III. Revisions, Clarifications, and Corrections to the Draft Supplemental EIR

This section of the Final Supplemental EIR provides changes to the Draft Supplemental EIR that have been made to revise, clarify, or correct the environmental impact analysis for Promenade 2035 (the Project). Such changes are a result of public and agency comments received in response to the Draft Supplemental EIR and/or additional information that has become available since publication of the Draft Supplemental EIR. The changes described in this section do not result in the Project creating any new or greater significant environmental impacts.

Figure III-1

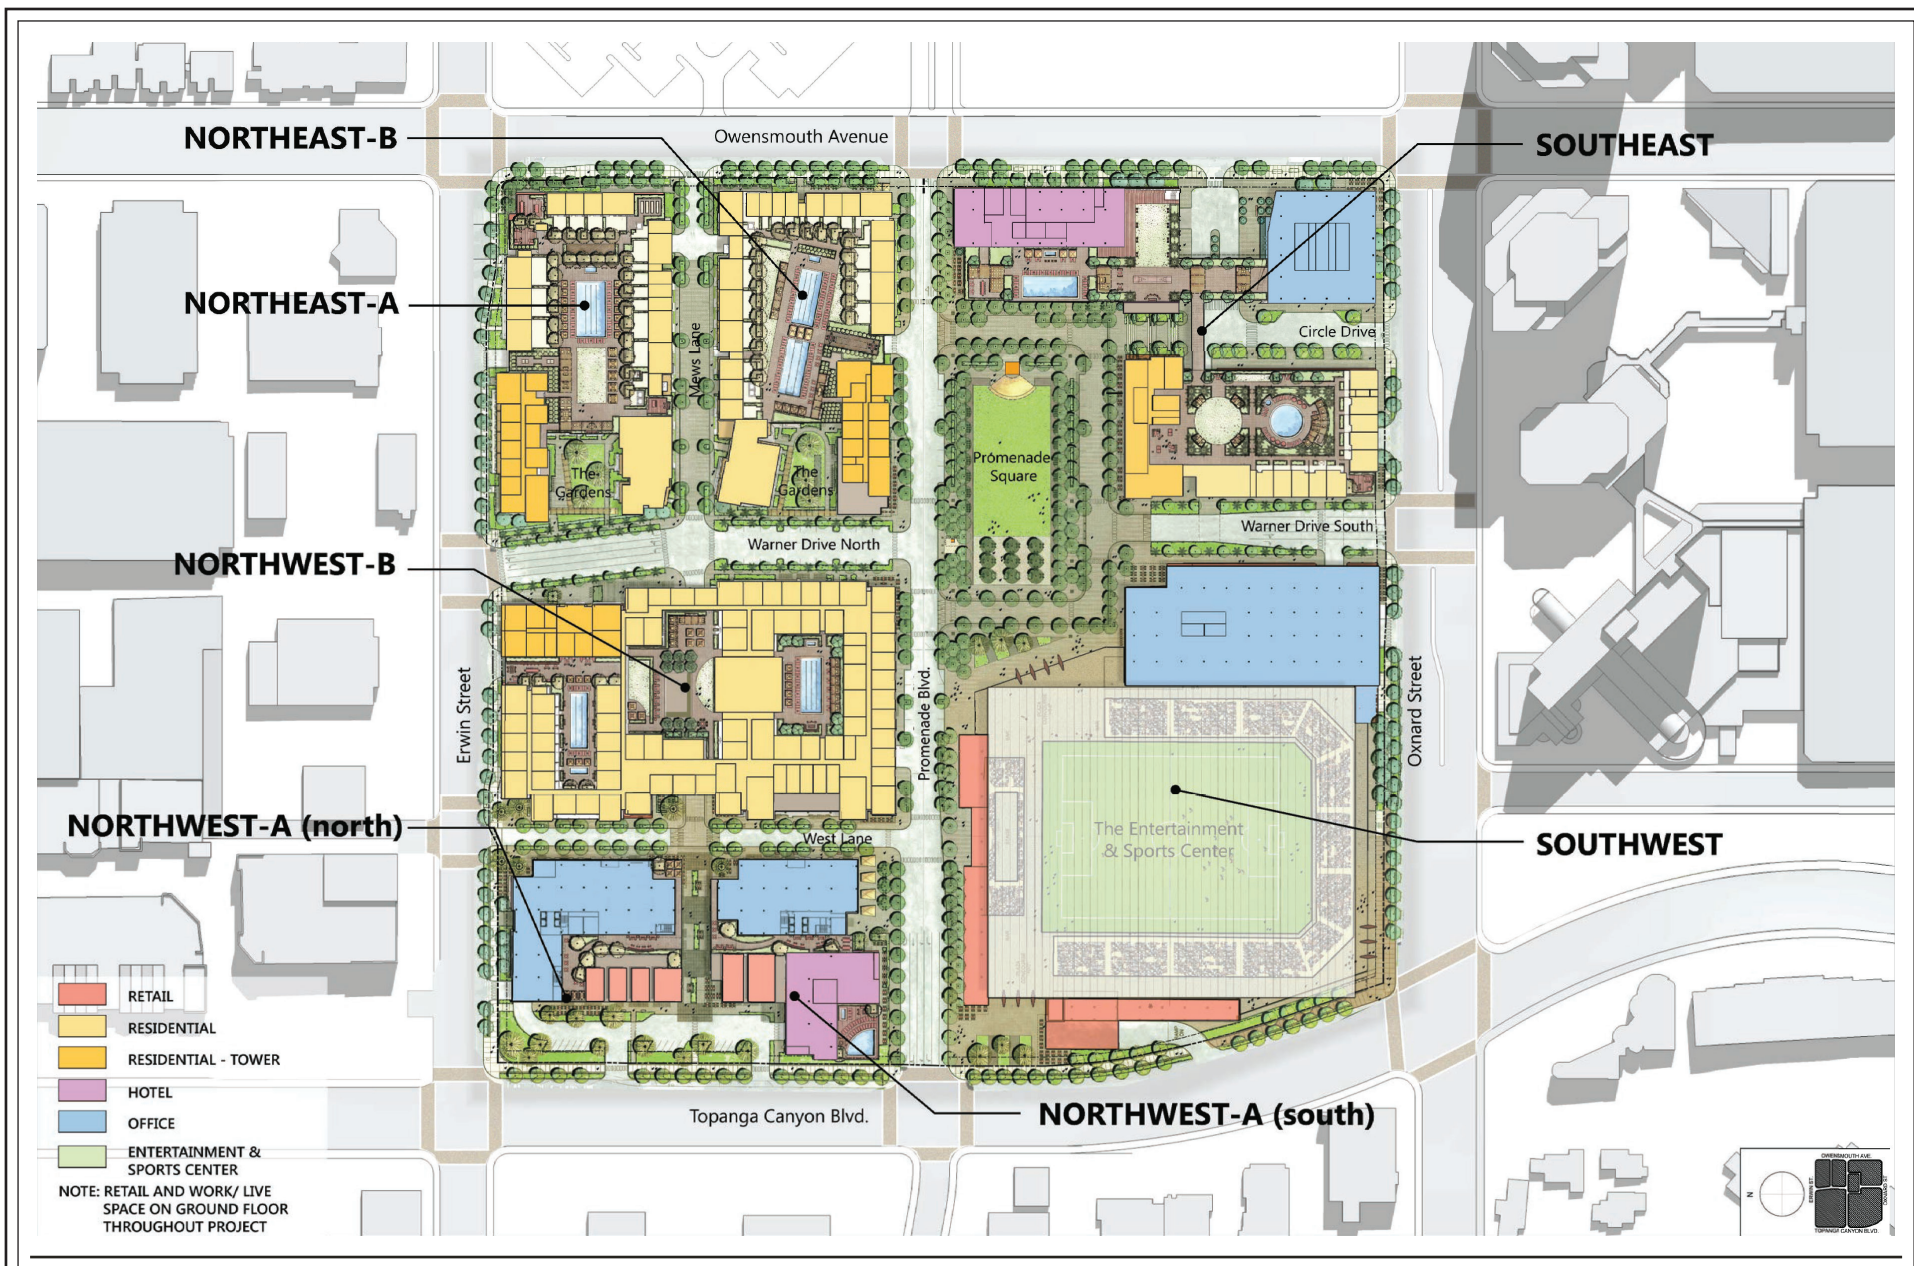
The “no roof” or “open roof” option described in the Draft Supplemental EIR for the Entertainment and Sports Center is more accurately described as a partial roof, as it includes an overhang extending over the seating areas of the Entertainment and Sports Center to provide shade, which would have additional benefits of providing some lighting and noise shielding. The partial roof would extend approximately 86 feet interior to the Entertainment and Sports Center from the exterior wall, as shown in Figure III-1 on page III-2. Therefore, the Final Supplemental EIR more accurately uses the term “partial roof” for this option, which applies throughout the Draft Supplemental EIR’s analysis of the “no roof” or “open roof” option. As a note, the Lighting Technical Report, provided in Appendix B, of the Draft Supplemental EIR, and the Noise Calculations: Methodology and Worksheets, provided in Appendix I, of the Draft Supplemental EIR, did account for the

approximately 86-foot partial roof in the analysis provided therein and described as the “no roof” or “open roof” option as it was formerly referred to in the Draft Supplemental EIR.

Figure IV.K-1a
Existing Transit Facilities

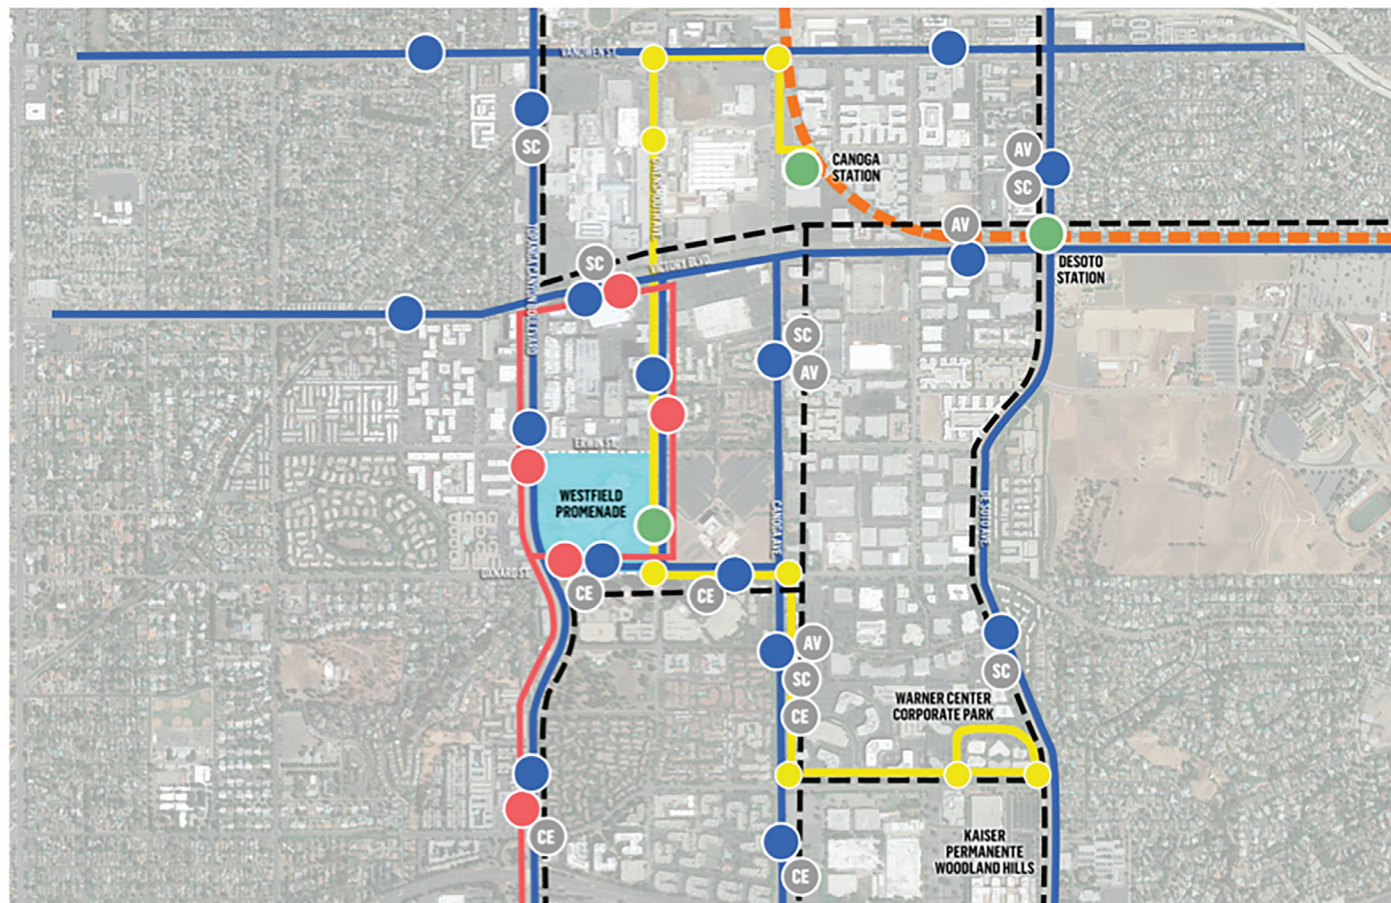
Volume 2, Section IV.K, Traffic, Access, and Parking, pages IV.K-10 and IV.K-12, beginning of last paragraph, revise and add Figure IV.K-1a as shown on page III-25, as follows:

Public transit service within the Study Area is currently provided by Metro, LADOT Transit Commuter Express (CE), the Santa Clarita Transit Line, the Antelope Valley Transit Authority, the Ventura County Transportation Commission, and Los Angeles County Topanga Beach Bus, as illustrated in, Figure IV.K-1a on page IV.K.12a. The following list presents a brief description of the 16 bus lines providing service in the vicinity of the Project Site:
